WATER
RESOURCES
DEPARTMENT

REQUEST FOR WRITTEN APPROVAL TO USE CONSTRUCTION METHODS NOT
INCLUDED IN THE RULES AND REGULATIONS PRESCRIBING GENERAL STANDARDS
FOR THE CONSTRUCTION AND MAINTENANCE OF WELLS IN OREGON

City of Troutdale Well #7 Special Riser Section

Proposed
2/12/93

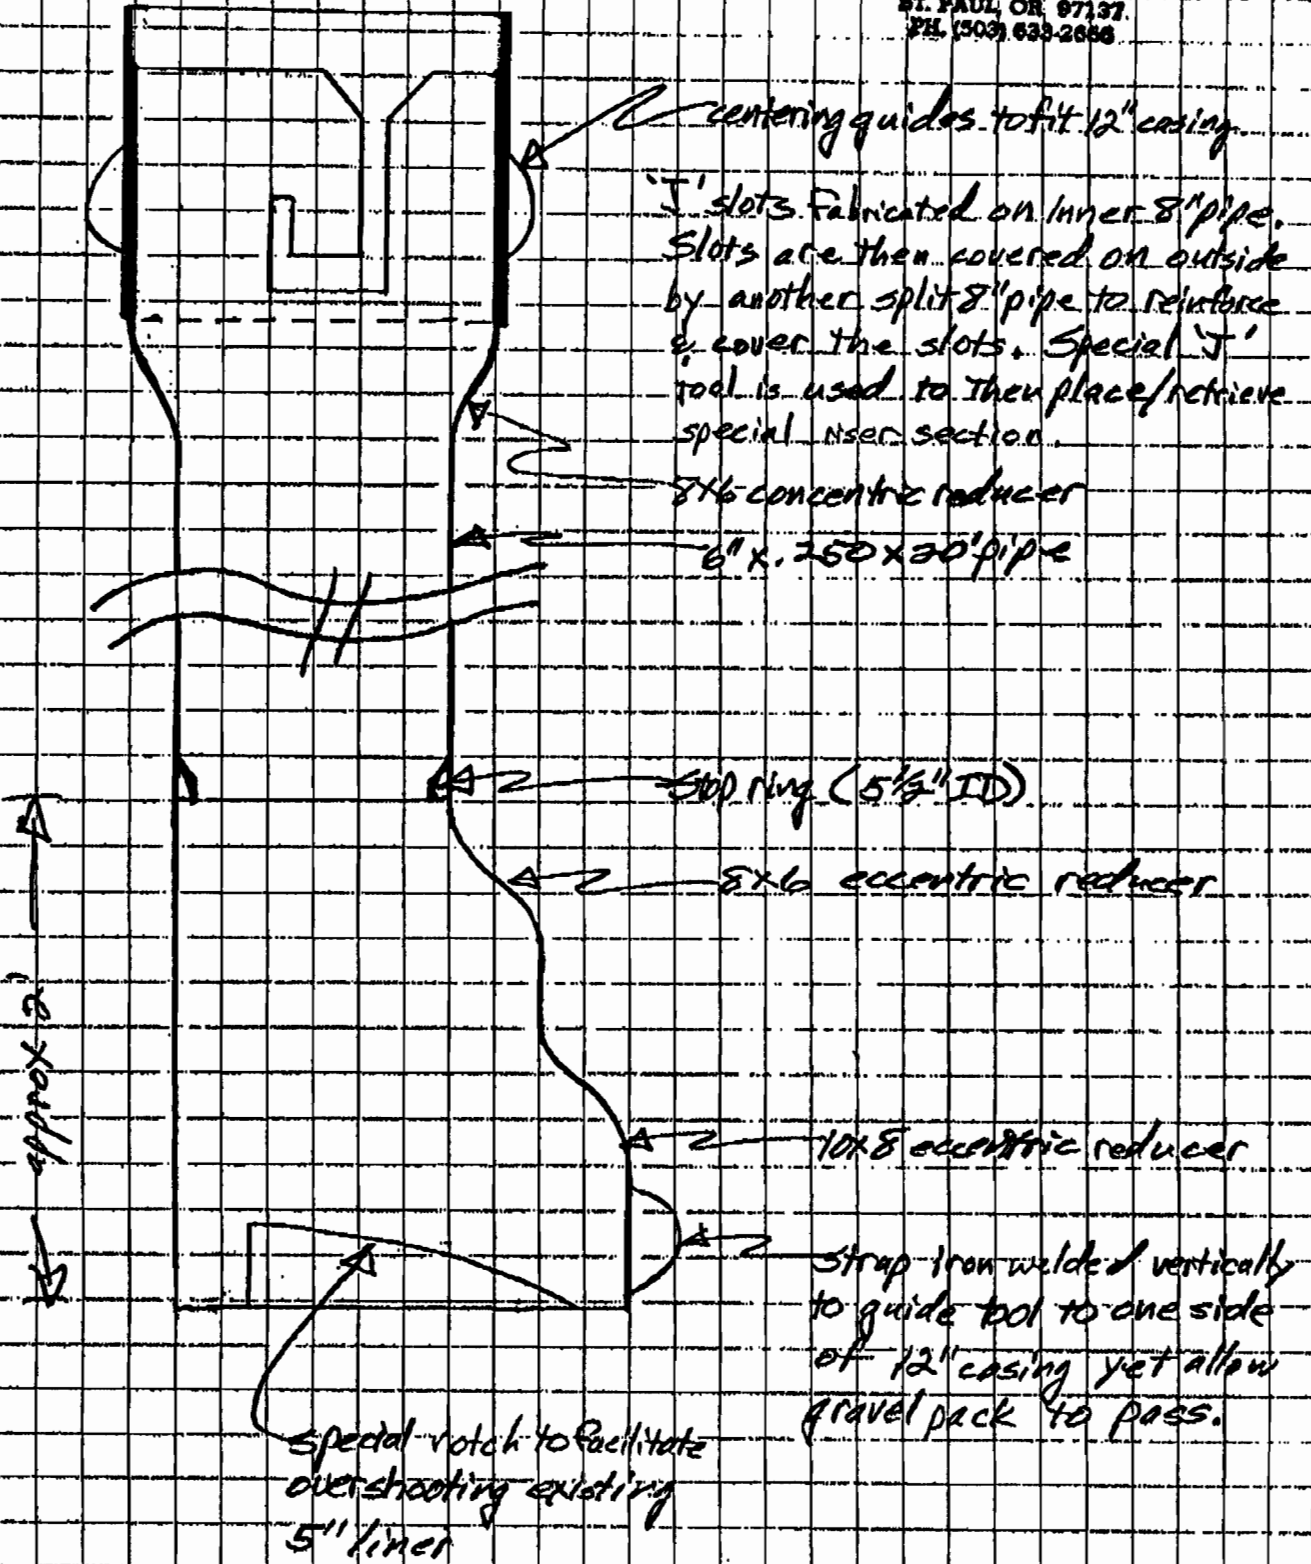
In your request, you indicate that the 5" liner/screen is not centered in the 12" casing and therefore the bottom of the hole is currently inaccessible to down-hole equipment. You propose to install a riser guide that will help guide the tools into the lower section of the well.

(4) The unusual conditions existing at the well site: 5" liner/screen
is not centered in 12" casing and cannot get
tools (bailey TV, etc.) into 5" without putting in a 6"
guide string of pipe everytime it is desired

Install special riser section that will hopefully
guide tools into 5" liner. The only need
for variance is that this section would not
overlap 5" liner by 8' because existing pack
would have to be removed and volume of reserve
pack in annulus would be reduced. Pack has
been known to settle as a result of sand production

Installation of this riser section would provide additional pack reserve. Also, 8' overlap would cover "relief" liner perforations.

Your special standards request is approved. The repair should allow greater access to the lower portion of the well, and facilitate down-hole equipment entry. If you have any questions concerning this letter, please contact me at the address or phone number listed below.
